ADDENDUM 1

CSP 23-27

GYMNASIUM ADDITIONS/IMPROVEMENTS FOR CAVAZOS & TREVINO ELEMENTARY SCHOOLS

ADDENDUM NO: ONE (1)

3 DEMO PLAN
1/8" = 1'-0"

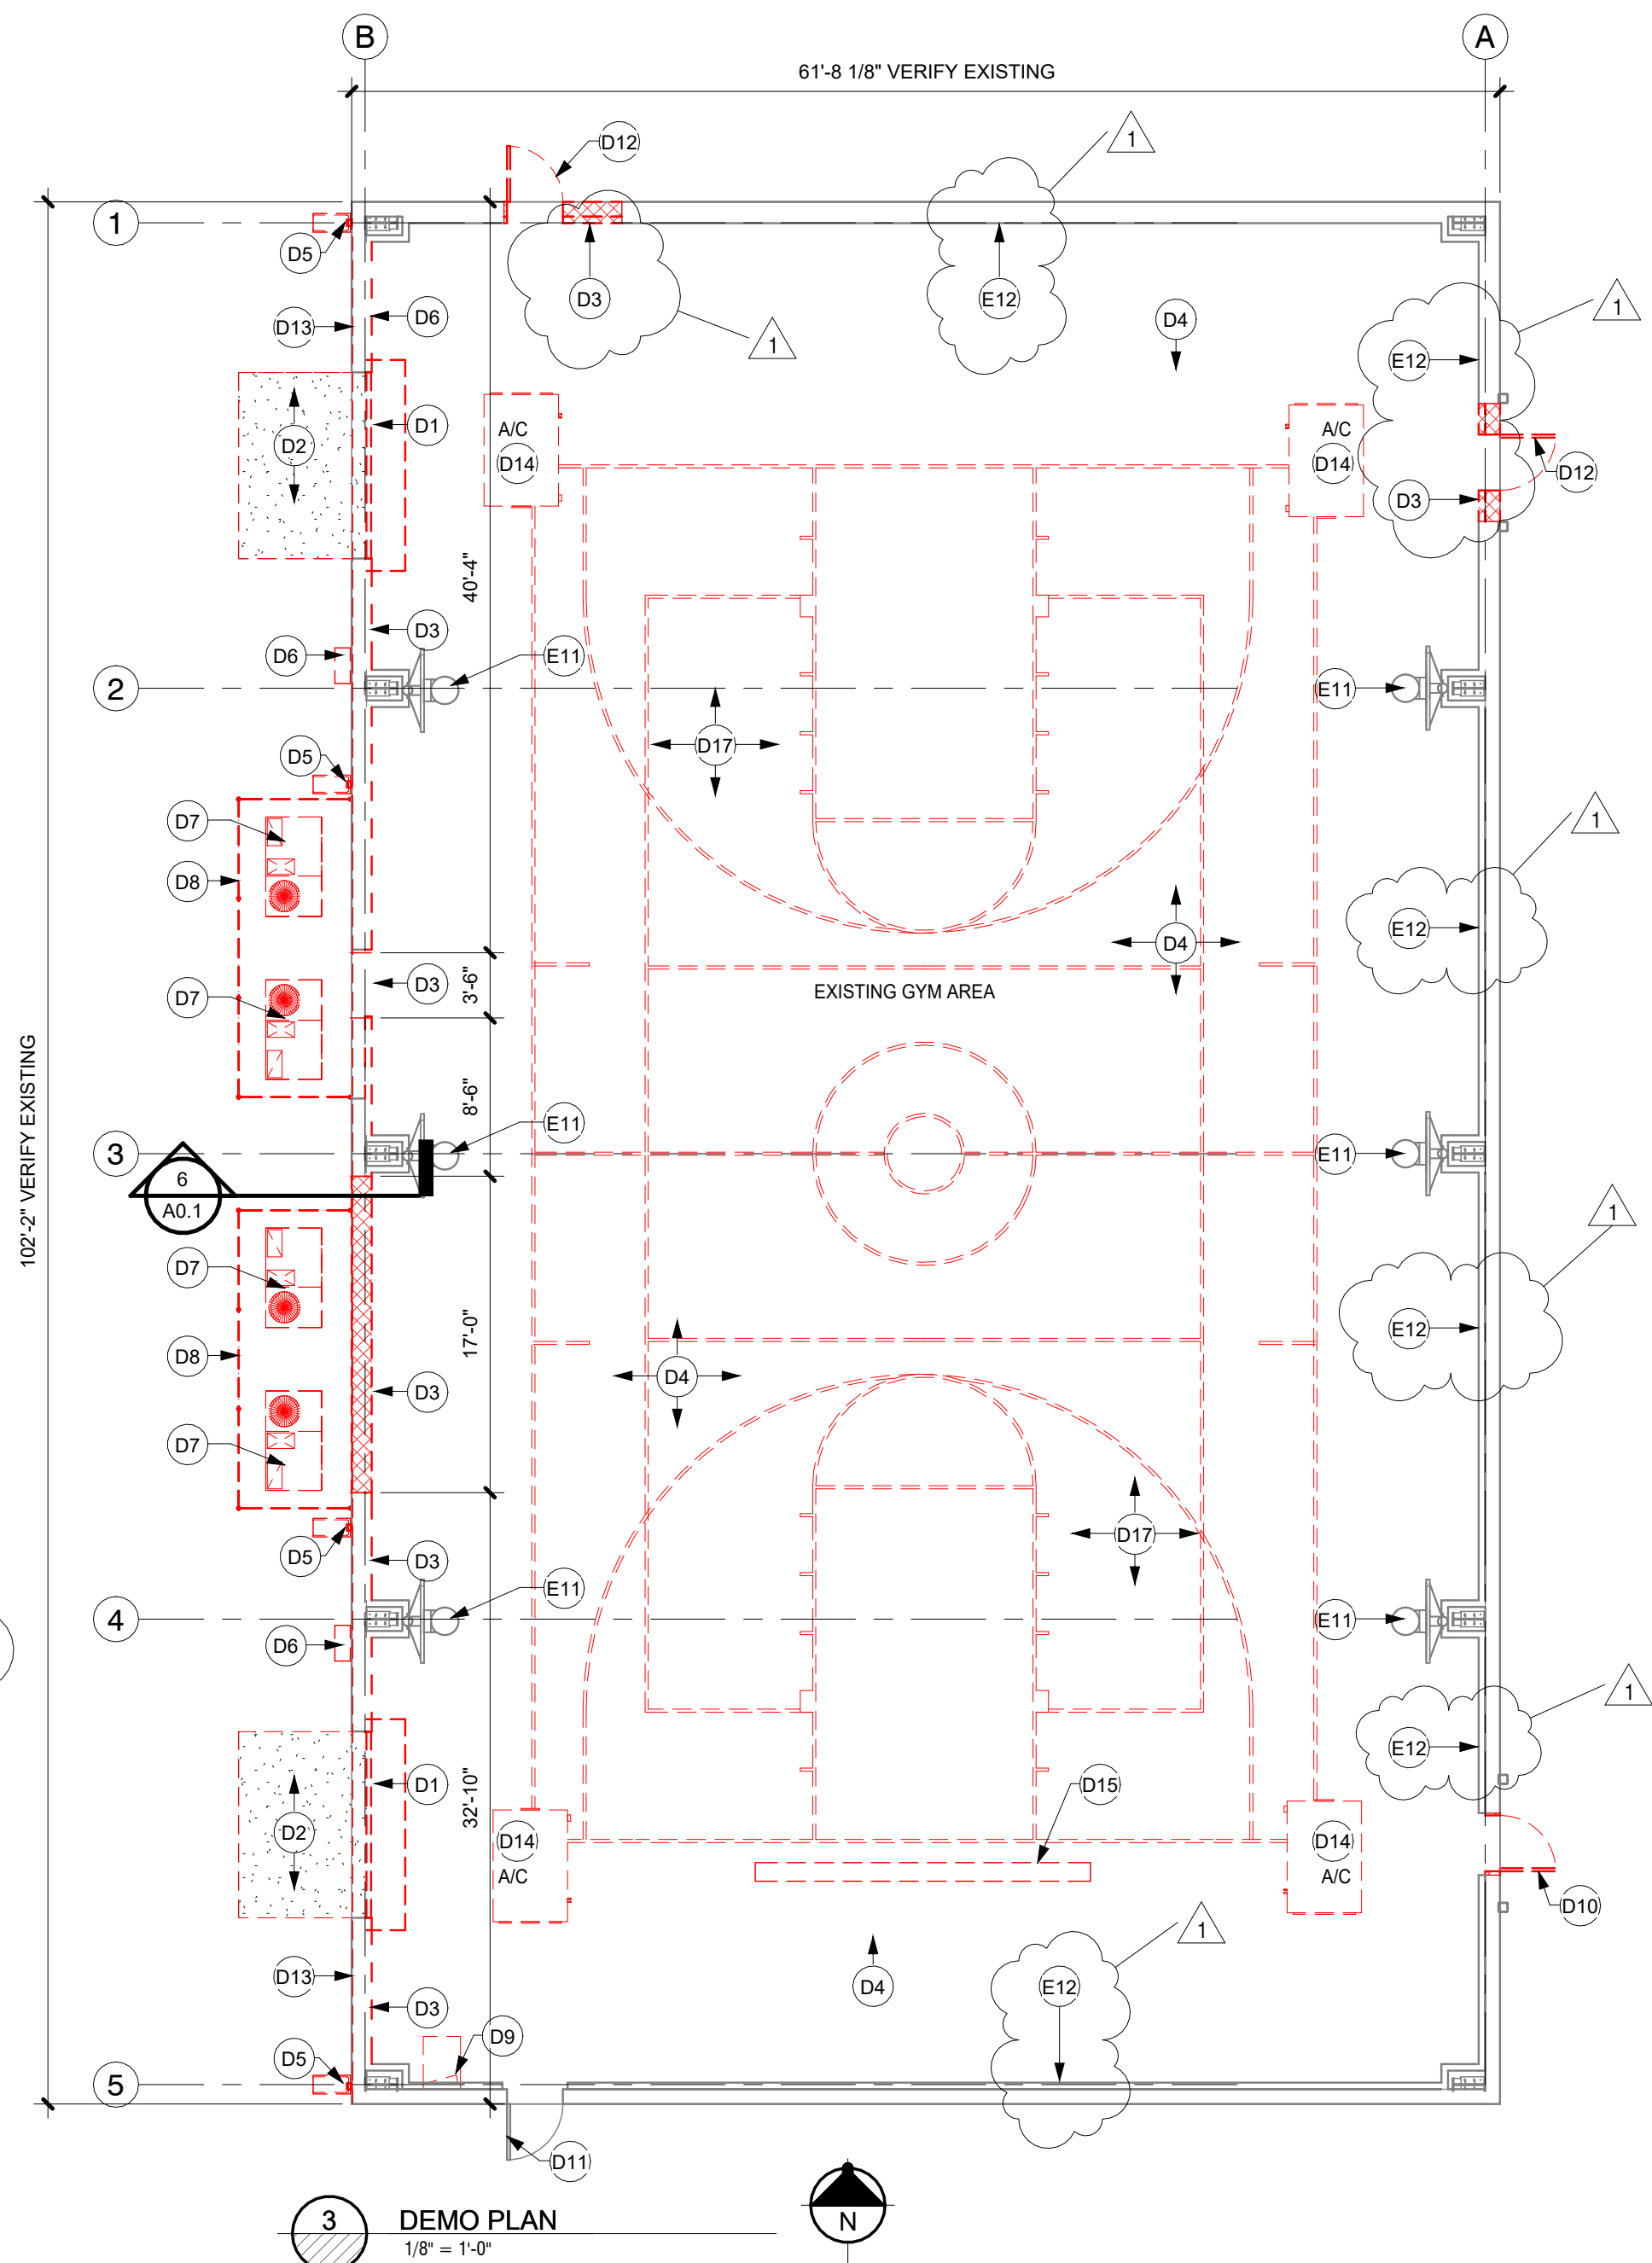
- d. At EXISTING CONDITIONS pictures, add keynotes (D3) and (E12)
 - e. At 3/A0.1 DEMO PLAN, add keynotes (D3) and (E12) to EXISTING GYM AREA north, east, and south walls.

A2.0

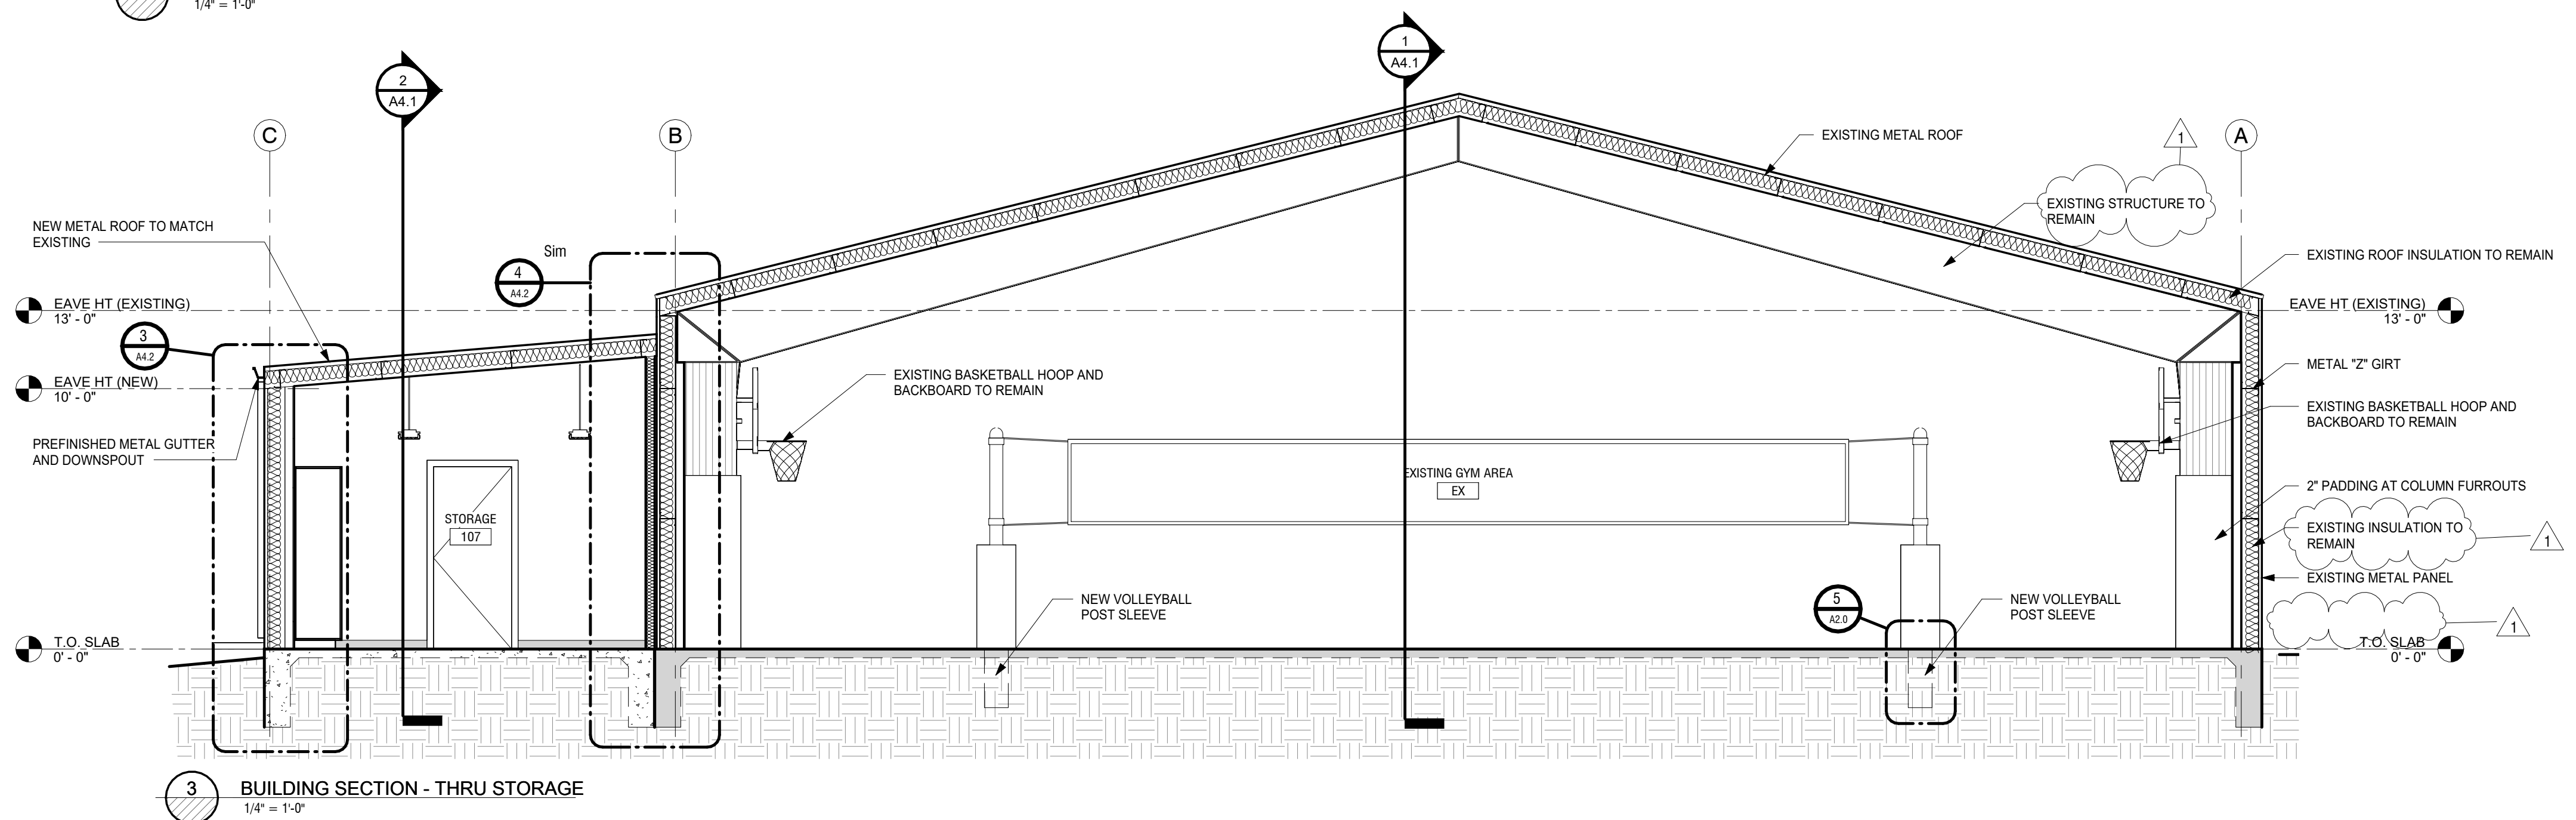
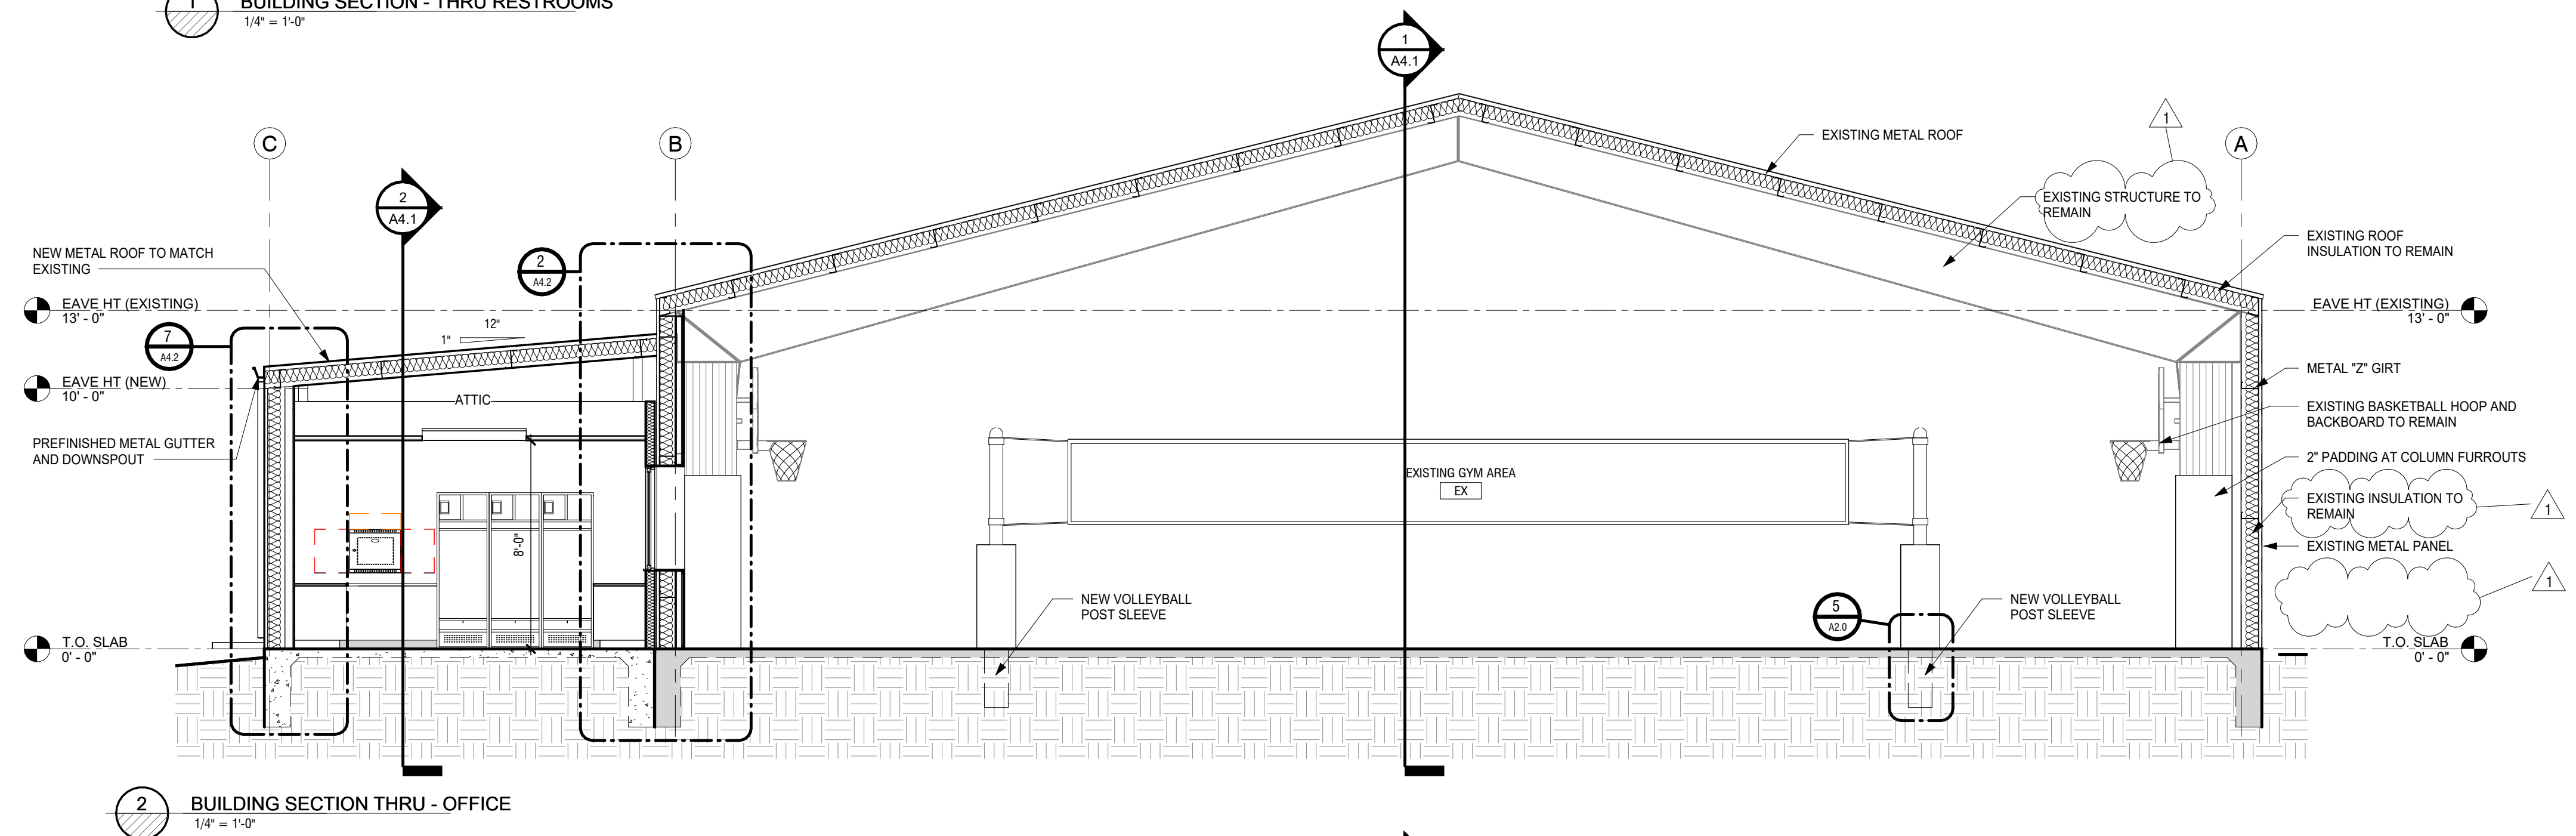
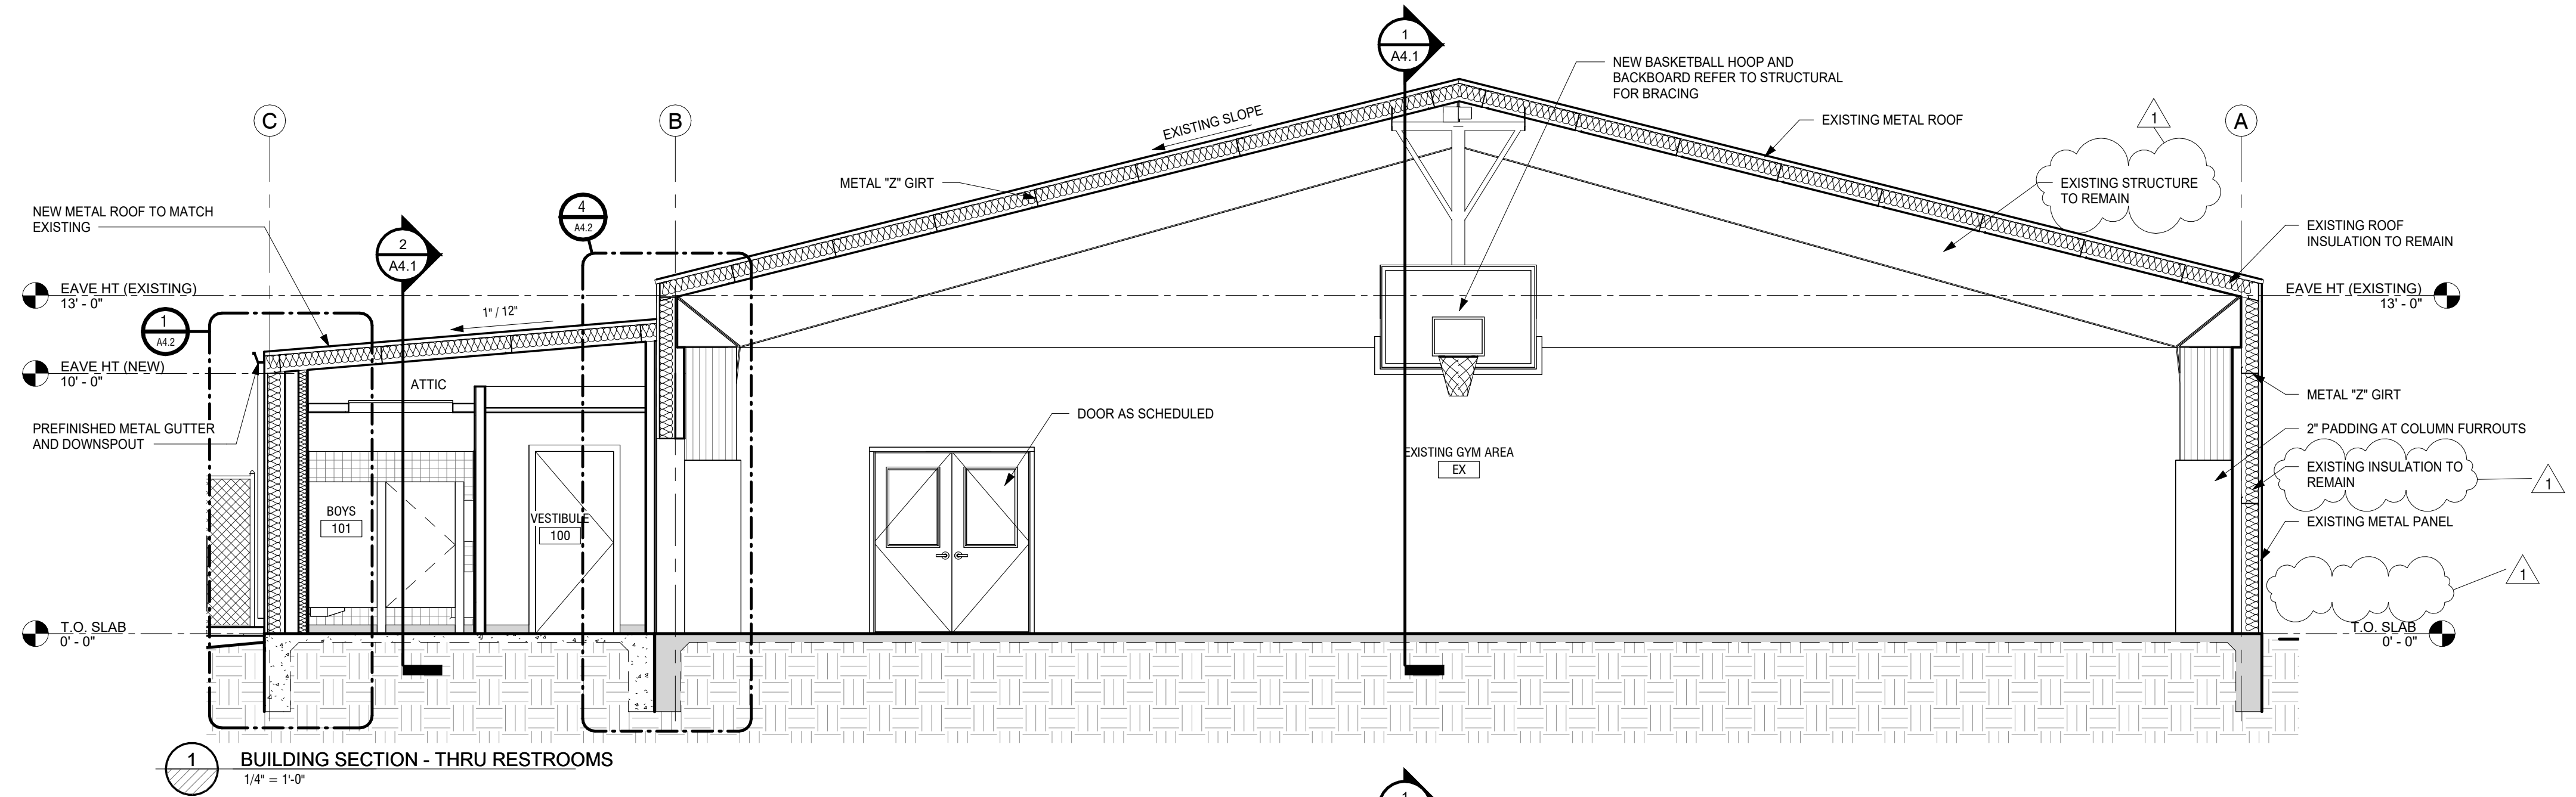
- f. At DEMOLITION KEYNOTES, modify keynotes (D1) and (D16) to read "NOT USED".
2. SHEET A2.0 NEW FLOOR PLAN (INCLUDED HEREWITH)
 - a. Add notes "ALL EXISTING WALL PANELS AND WOOD TRIM TO EXPOSED TO VIEW TO BE REPAINTED", add this note at gym north, east, and south walls.

- b. Add note "ALL EXISTING PANELS AND WOOD TRIM EXPOSED TO VIEW TO BE PAINTED OR REPAINTED, EXISTING WALL PANELS TO REMAIN EXCEPT AT NEW OPENINGS, PROVIDE NEW 1x WOOD TRIM AT ALL NEW OPENINGS BOTH SIDES", add this note at gym west wall.
